Purpose: This Amendment No. 1 to the Tehama County Transit Agency Board's (TCTAB's) Request for Information (RFI) for Transit Workforce Management/Automation Applications provides answers to questions received to date from potential respondents. It also provides an extension to the due date for responses and it makes two (2) other changes to the RFI as listed in the "Impact to RFI" section included on Page 3 of this Amendment.

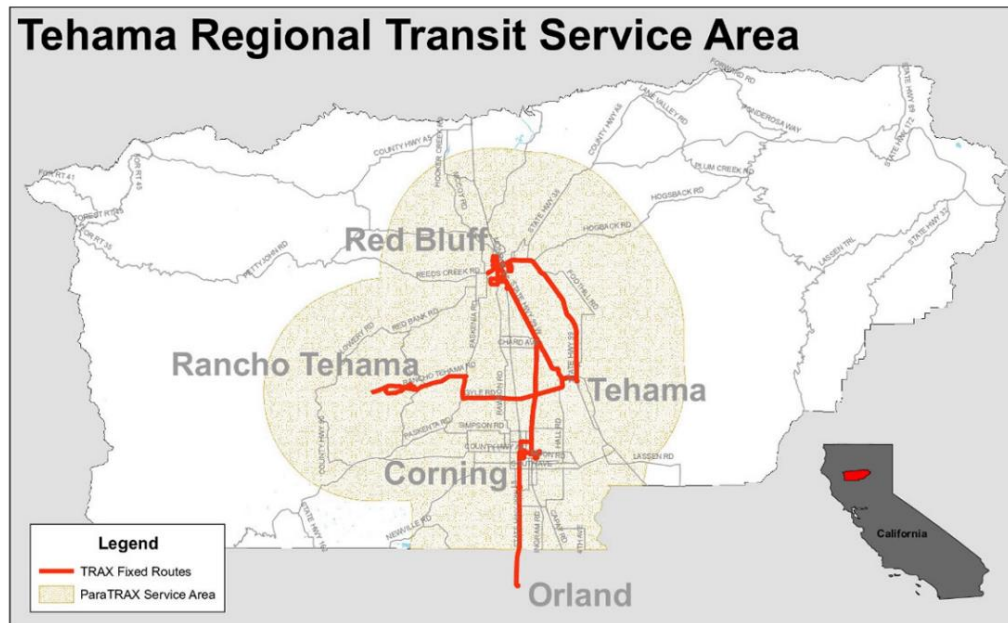
3. Does the current radio system provide good connectivity in the fixed-route service area? or are there dead zones?

Answer: The new/replacement radio service, as noted in the answer to question #2, is described as having acceptable coverage throughout TRAX's and ParaTRAX's service area with some dead spots at the area's periphery. For reference, the following graphic shows the service area of TRAX and ParaTRAX.

Impact #2: The RFI's "Background" section titled "BACKGROUND – TWO WAY RADIO CAPABILITIES" is to be corrected with and superseded by the information included in the answers to questions 2 and 3 in this Amendment No.1.
